## FCC C2PC Request Letter

SUBJECT: Class II permissive change for FCC ID: 2AB2Q-BHAKP001

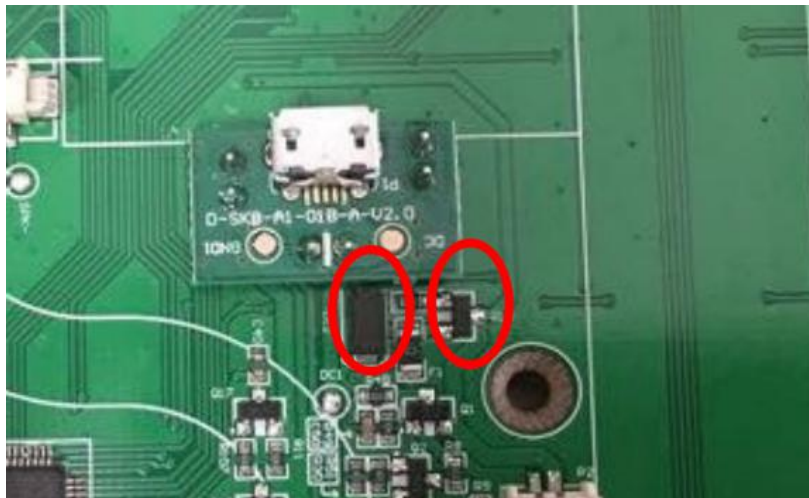
Change 3: : Remove Component D12, and Component Q16 pin D to pin S short circuit.

To reduce the noise from the speakers, will not affect the performance of the radio frequency
